DATE: November 29, 2021

SUBJECT: Joint Water Quality Commission - Land Disposal System Evaluation Report,
WPDES Permit # WI-0063797**Effluent & Groundwater Evaluation Summary****Table 1 Effluent Parameters and Limits**

Figure 1
Chloride

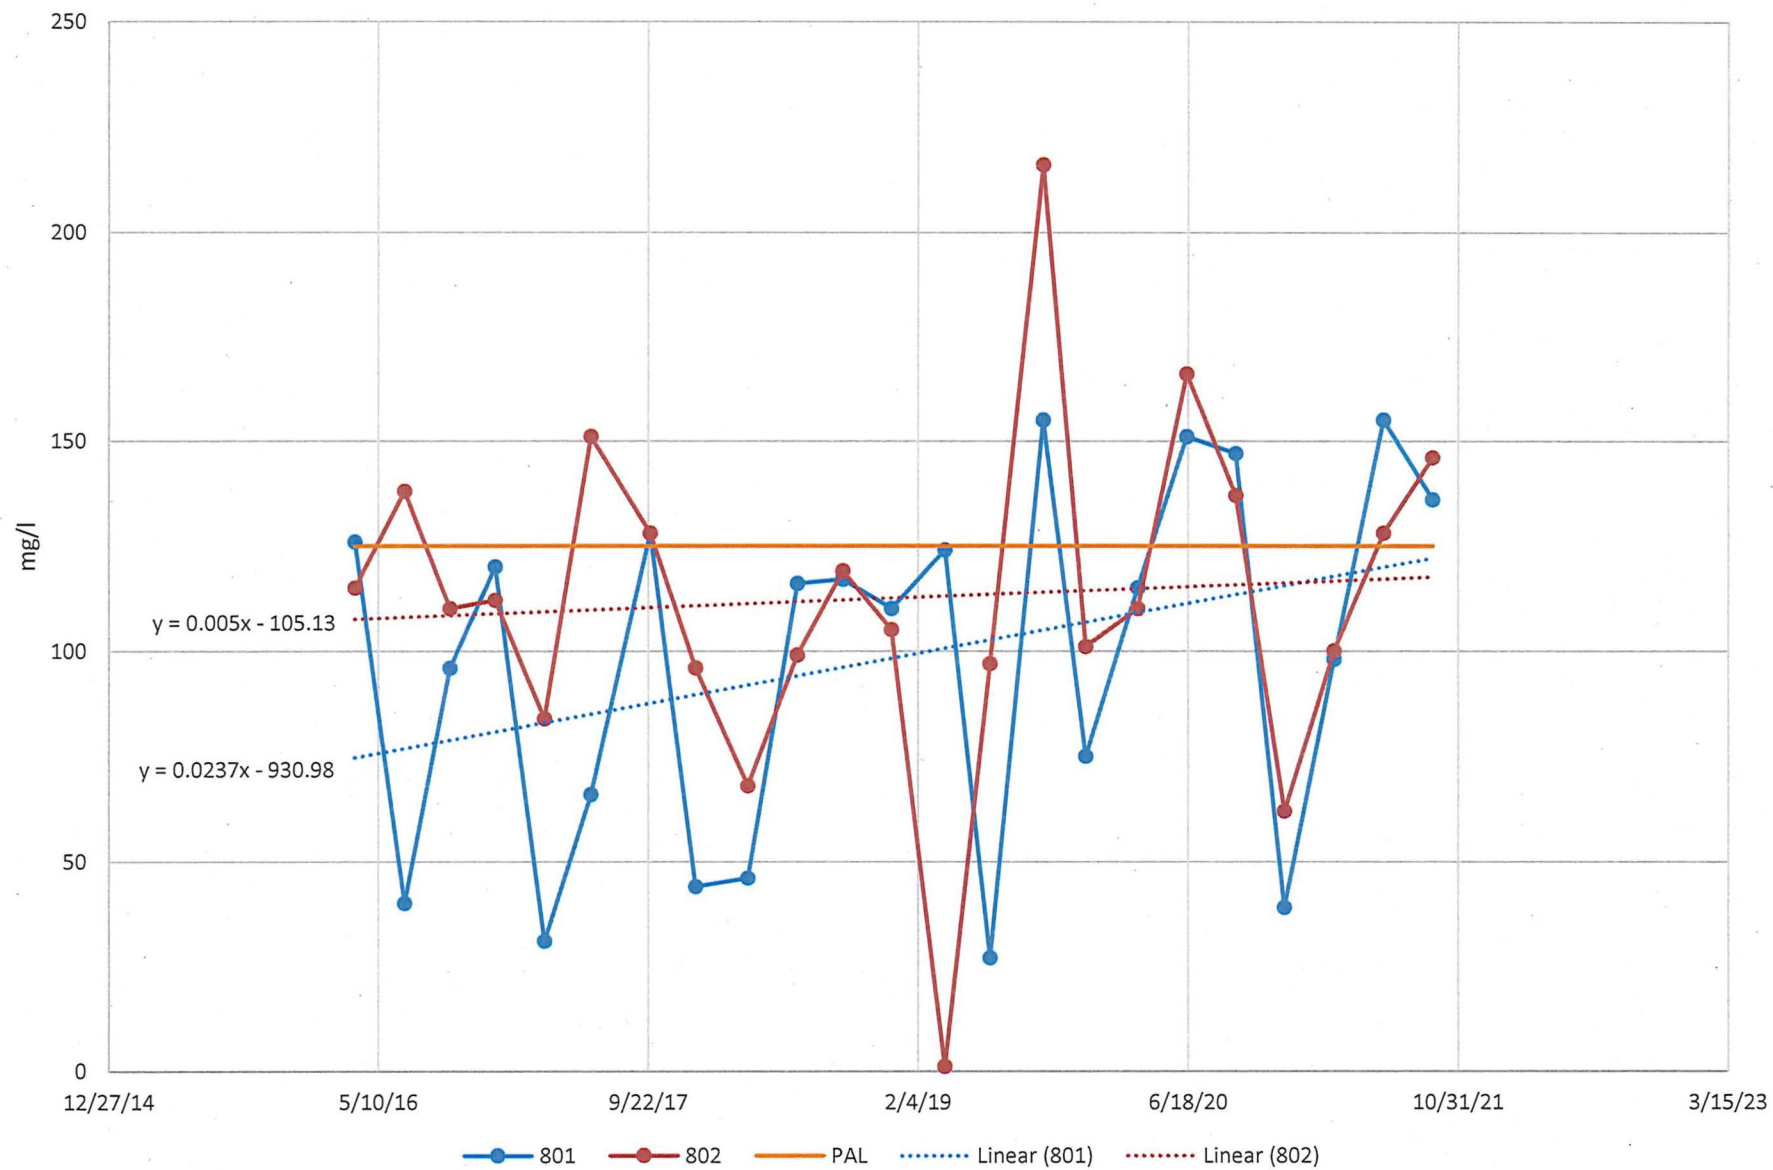
The chloride exceedances of groundwater quality standards were observed in well 801 and 802. These exceedances did not achieve or exceed the ES. However, the groundwater monitoring results were graphed, and a “best-fit” trend line was assigned. See Figure 1. The slope intercept for the trend line is shallow and has a positive slope for both wells 801 and 802. This means the concentration is increasing over time.
